APP-GW-GLN-016, Revision 0

“AP1000 Licensing Design Change Document for Generic Reactor Coolant Pump”

TITLE: **AP1000 Licensing Design Change Document for Generic Reactor Coolant Pump**

This report summarizes changes to the AP1000 reactor coolant pump design which have resulted from detailed design work. The major changes include:

Revised Figure 5.1-5 Sheet 3

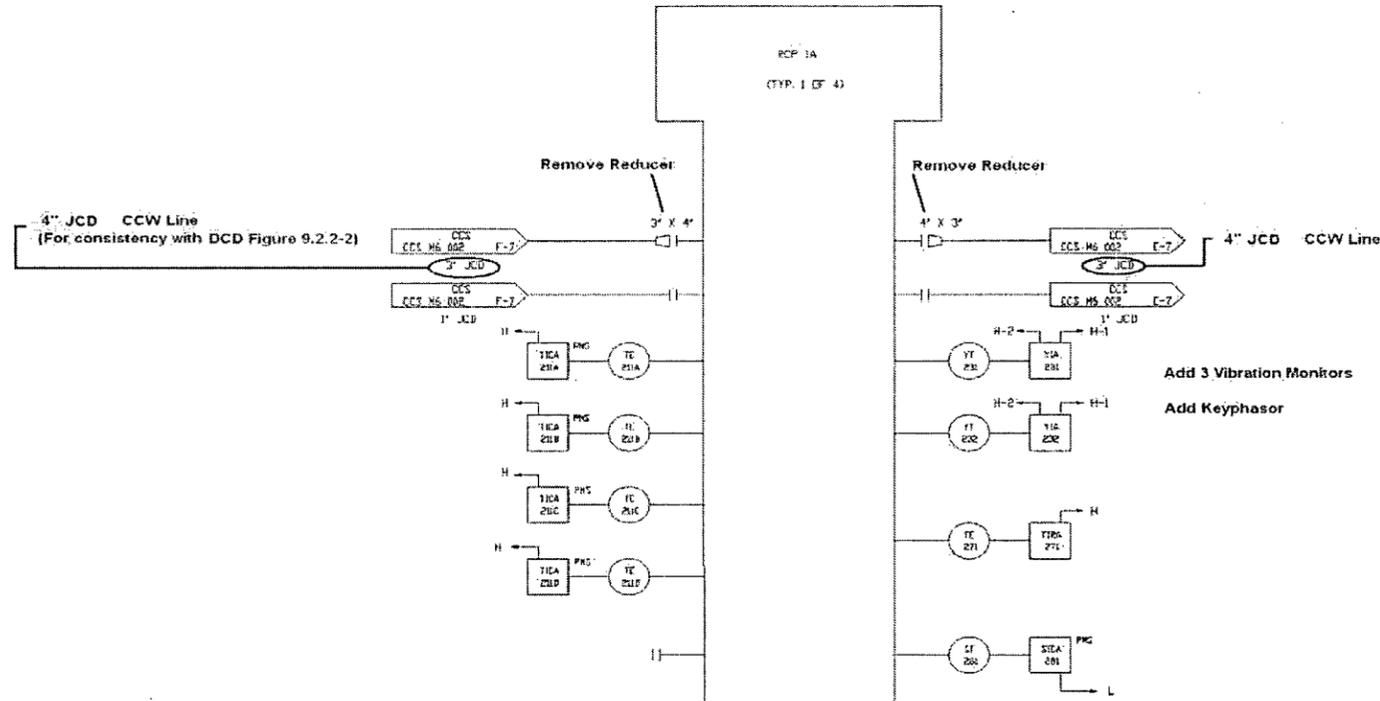
Revise Figure 5.1-5 Sheet 3 according to markup on next page:

Add 3 Vibration Monitors per Pump
 RCP 1A 1B 2A 2B
 Existing 231A 232A 233A 234A
 231B 232B 233B 234B
 231C 232C 233C 234C
 Additional 231D 232D 233D 234D
 231E 232E 233E 234E

Add 1 Keyphasor per Pump
 RCP 1A 1B 2A 2B
 261 262 263 264

Figure 5.4-1
Reactor Coolant Pump

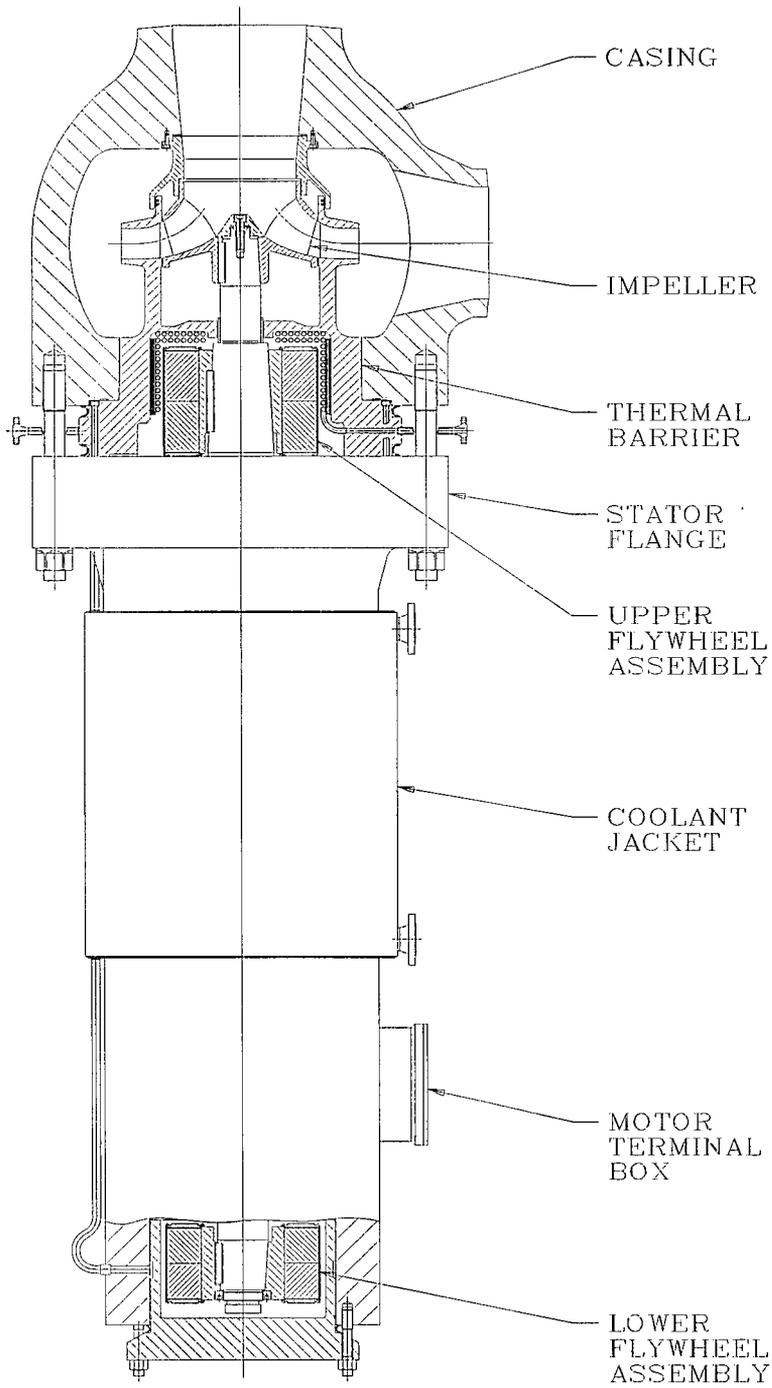
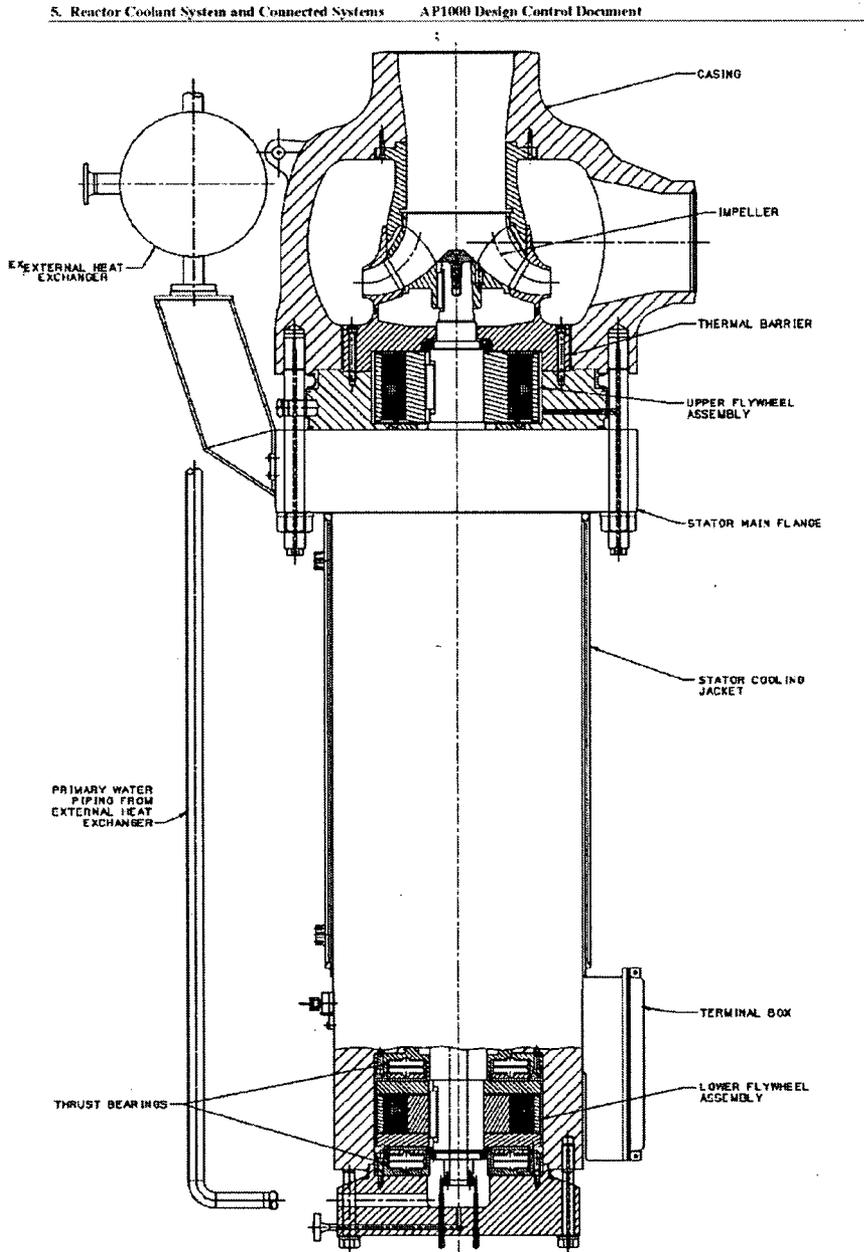
By increasing the inertia of the rotating assembly to maintain the pump coastdown required to support the safety analyses, the rotordynamics of the rotating assembly have been changed. To meet the rotordynamic requirements, the thrust bearing assembly has been modified from the previous configuration depicted in Tier 2, Figure 5.4-1.

The updated design incorporates the lower flywheel into the thrust bearing assembly. Two separate thrust runners are mounted with minimal clearance from the top and bottom of the lower flywheel. Upper and lower mounted thrust bearings borrow structural stiffness from the flywheel. In addition to providing acceptable and improved rotordynamics, the updated design provides the required inertia within the RCP space envelope while minimizing fluid frictional forces on the end faces of the lower flywheel.

The preliminary design of the reactor coolant pump dissipated heat from the motor cavity by means of internal cooling coils near the thermal barrier (thermal barrier heat exchanger) and an external heat exchanger which wrapped around the outside of the motor stator (wraparound heat exchanger). Heat removal components of the reactor coolant pump described in Tier 2 of the DCD reflect this preliminary heat removal configuration.

As the detailed design of the pump has progressed, the heat transfer requirements on the heat exchanger have increased due to increased motor power requirements and the detailed analysis of the effects of design transients on motor operation. The current heat removal requirements have resulted in significant manufacturing challenges associated with the wraparound heat exchanger design. A conventional shell and tube heat exchanger mounted on the pump flange has been implemented to replace the current wraparound heat exchanger.

As a result of detailed stress analyses and evaluations of installation and in-service inspection requirements, the pump casing nominal dimension from the centerline of the suction nozzle to the end of the discharge nozzle was increased from 48.25 inches to 53.5 inches (an increase of 5.25 inches). The nominal length of the cold leg pipes decreases a corresponding 5.25 inches, such that the actual positions of the steam generator/reactor coolant pump and reactor vessel do not change.

Stress analyses results of the current casing discharge nozzle showed that the allowable stresses were exceeded. To reduce the stresses in the casing, the wall thickness near the discharge nozzle was increased, which results in an increase (2.25 inches) in the length of the discharge nozzle.

Evaluation of the in-service inspection requirements of the casing discharge nozzle to cold leg piping weld showed that, to meet the current practices for the ultrasonic inspection of the weld, a straight nozzle length of at least 4.6 inches from the centerline of the weld will be required to provide an adequate mounting surface for the inspection probe.

- Tier 2: Figure 5.4-1

Revised Figure to Replace Figure 5.4-1:
